COBBORA COAL PROJECT

Re: Cobbora Coal Preferred Project Report - Review of surface and groundwater assessment and management proposals

Figure 1: Simulated life-of-mine Pit water storage (1944-1964 climatic sequence)

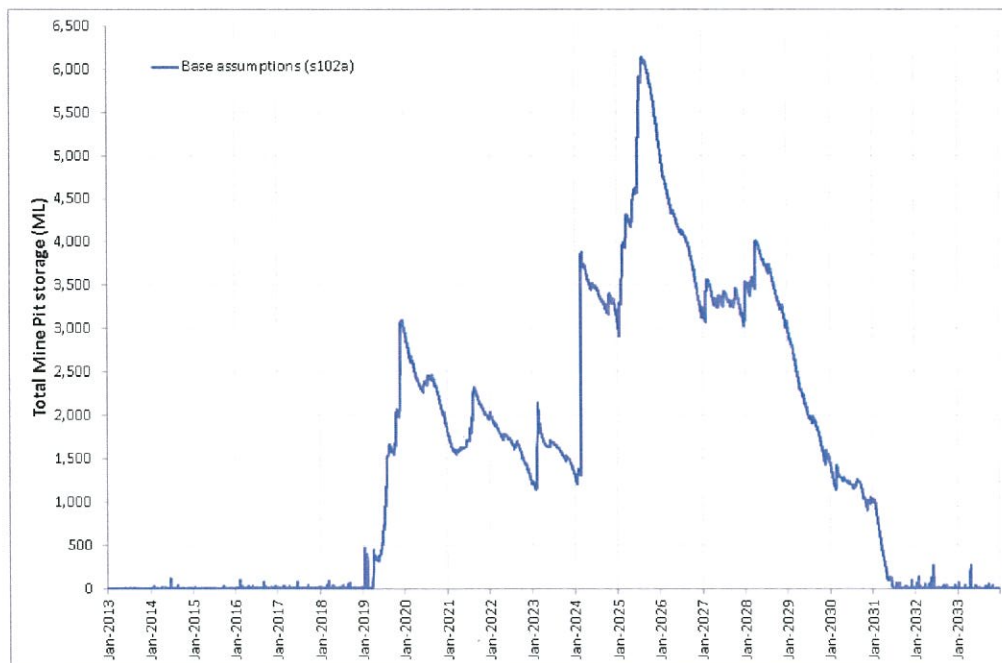
Results of the G&S modelling exercise indicate that even under base case assumptions (Scenario S102a), there is the potential for significant volumes of water to require storage/management within the mine pits over extended periods of the Project life, as shown in Figure 1. Results also show that the mine water management system is sensitive to the adopted runoff assumptions for the Pit and 'industrial' areas and changes in the amount of water returning from the Tailings Storage Facility.

Results from the base case scenario modelling indicate extended periods where volumes of greater than 2,000 ML are required to be stored within the pits occurring within some 50% of climatic sequences assessed. Similarly, results show required total pit storages of greater than 5000ML in some 15% of climatic sequences. Figure 1 shows an example of life of mine pit water storage behaviour for one such climatic sequence. Of particular importance is the extended and continuous period of more than 10 years with greater than 1500ML, and more than 5 years requiring management of 3000ML or more. Whilst the climatic conditions for this sequence are above average, they could not be considered 'extreme'.

In short, modelling shows the potential for significant interruption to mining activities due to water stored in Pits, which appears to have not been recognised or acknowledged in the mine water management plan. The storage of significant volumes within the pit is neither highly unlikely nor would it be infrequent as is implied by the PPR. Subsequently, it would appear that the mine water system is designed to operate under favourable (i.e. low to median rainfall) conditions only. The implications of this would be a high risk of significant and prolonged periods of interruptions to mining activities (of an already apparently economically constrained project) and/or a requirement for emergency discharge of stored mine water.

Figure 2: Base case simulated life-of-mine Pit water storage (1992-2012 climatic sequence)

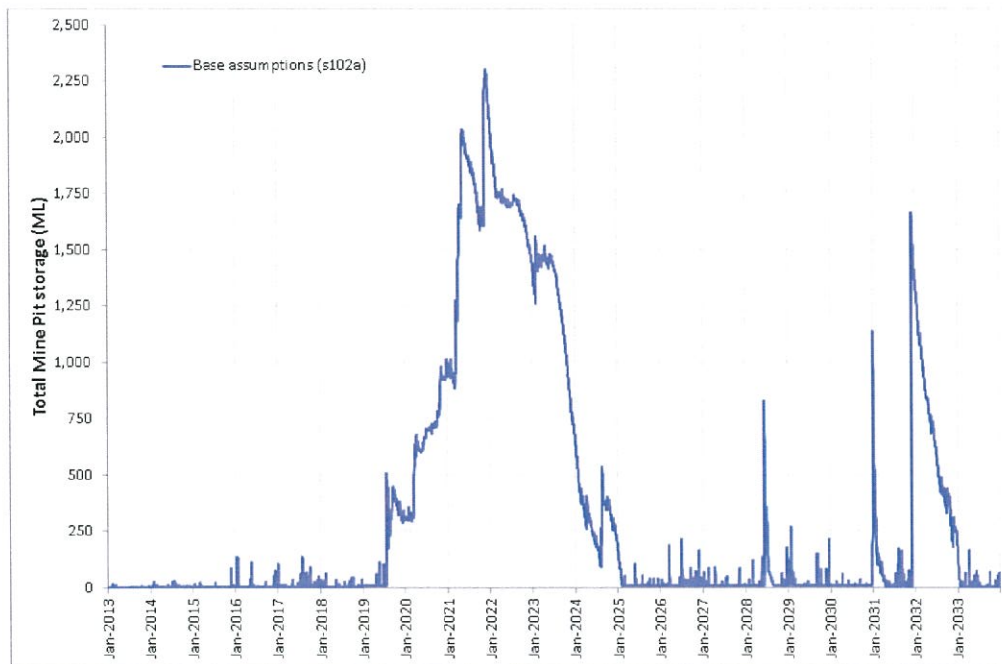
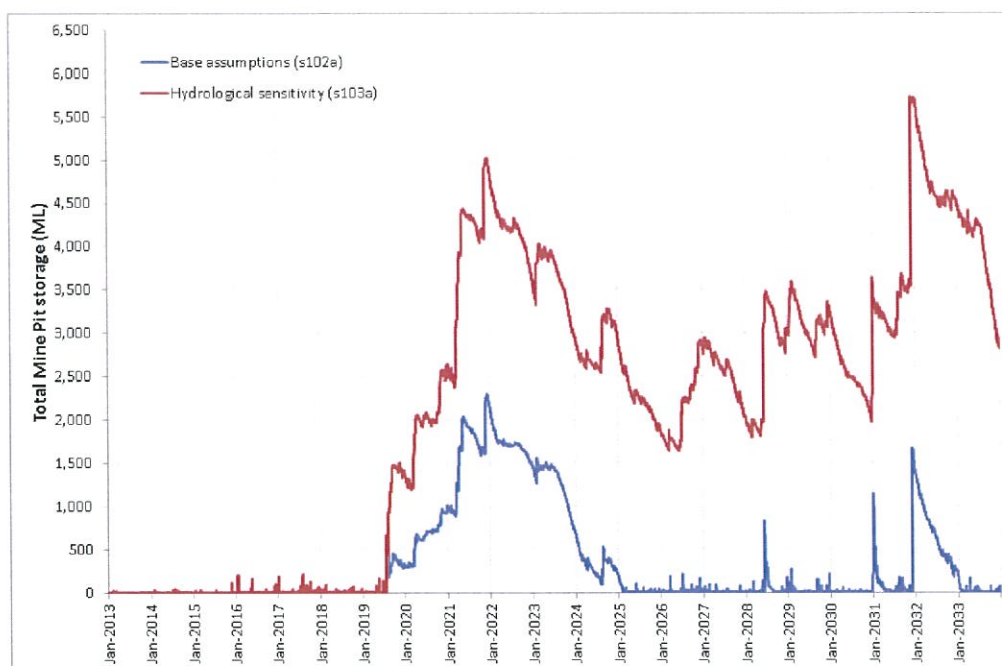
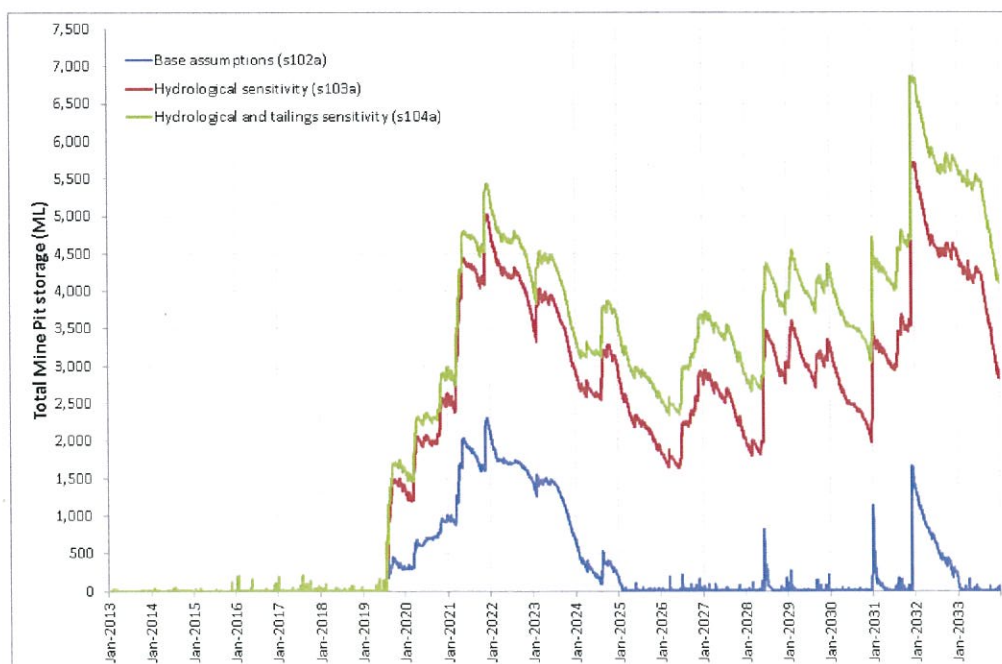
Further, the above results are based on a set of assumptions as adopted in the PPR. Sensitivity testing of a number of key assumptions indicates that the mine WMS is particularly sensitive to changes in the selected runoff characteristics for the active pit and industrial areas, as well as the simple decant rate assumption currently adopted. The degree of sensitivity is shown in Figures 2 – 4, illustrating simulated storage behavior under base case hydrological sensitivity and hydrological plus tailings sensitivity scenarios.

A point of note is that even under base case assumptions and what could be considered in the main a relatively dry 21 year period (Figure 2) there was still a continuous period of some 3 years where the volume of water requiring storage in the pits was between 1000ML and 2500ML.

Figure 1: Comparison of groundwater to mine inflow rates in Mining area A

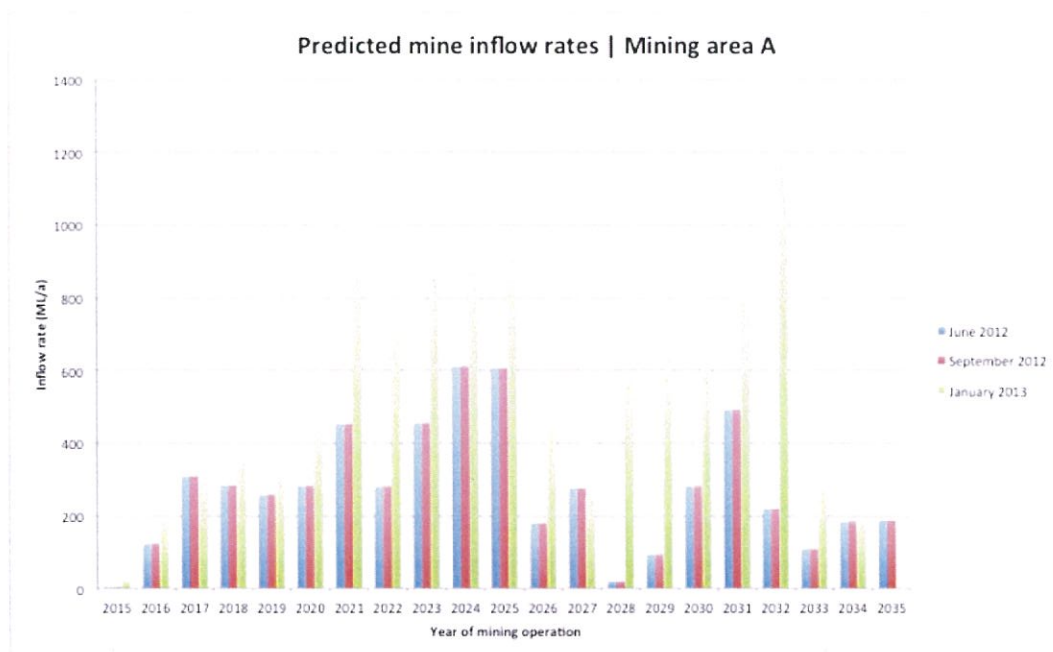
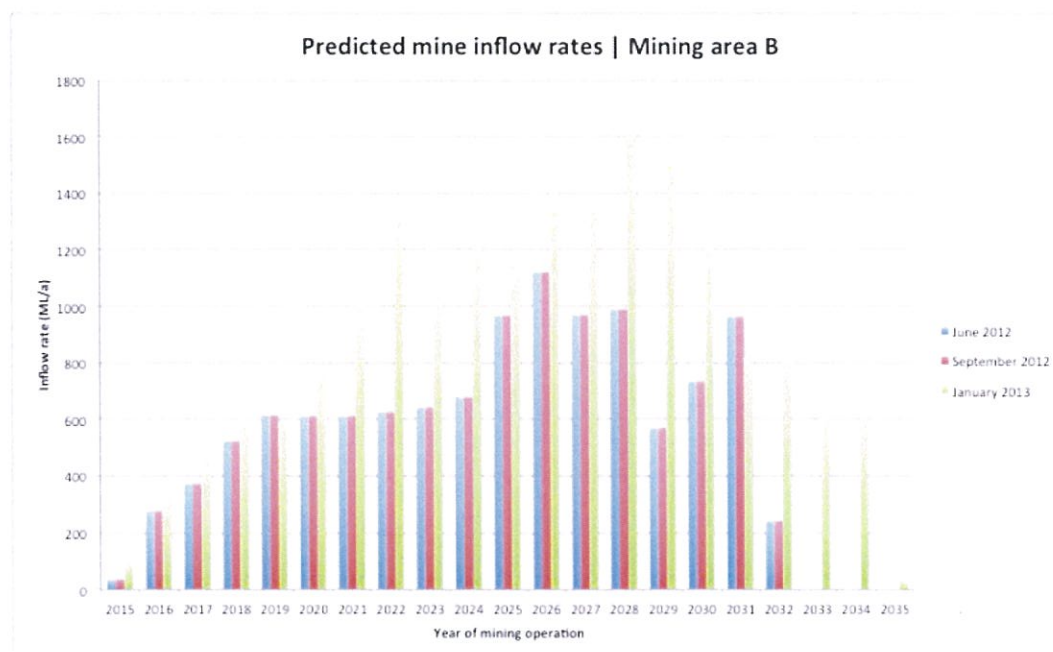
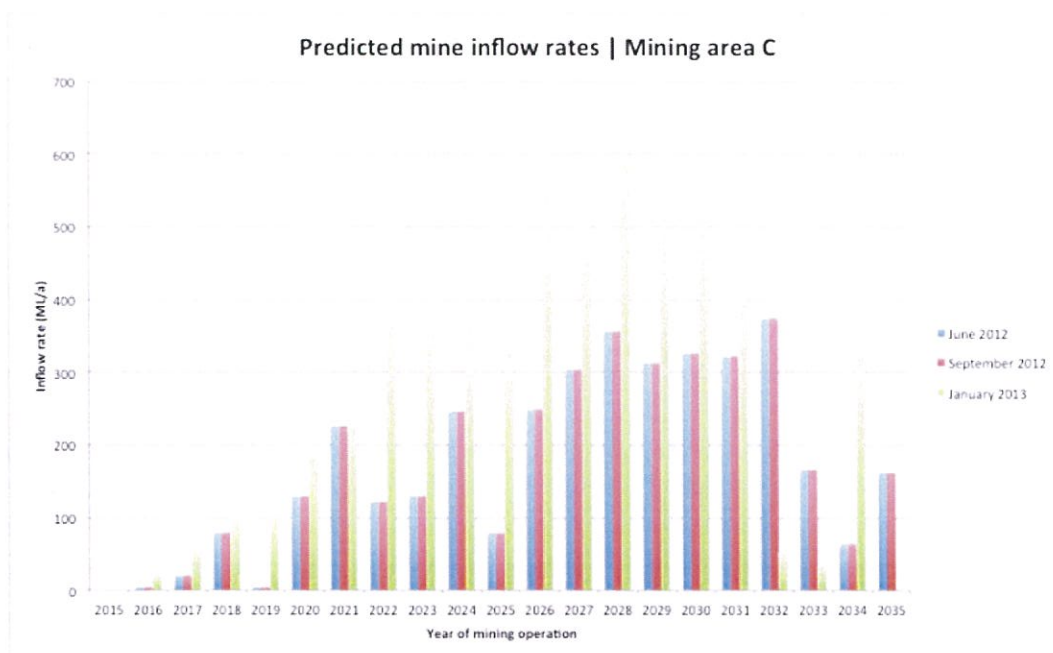
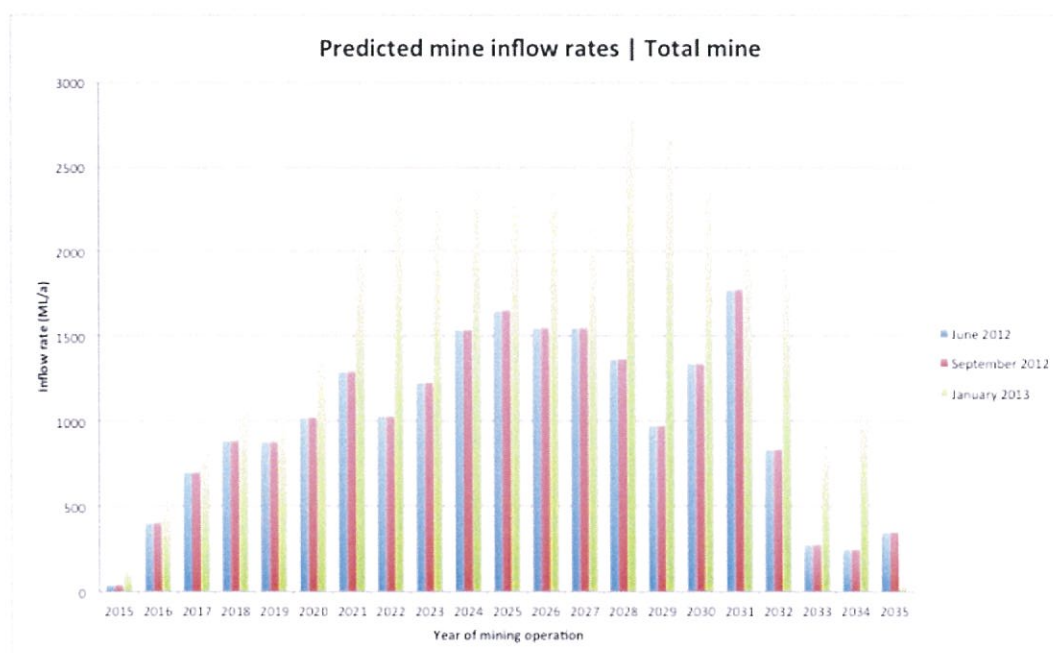
- Further changes to modelling results are evidenced in the graphs of mine inflow rates, provided below. Predicted inflow rates have increased since the earlier iterations of the report. The impact of such changes is not clearly described in the PPR.
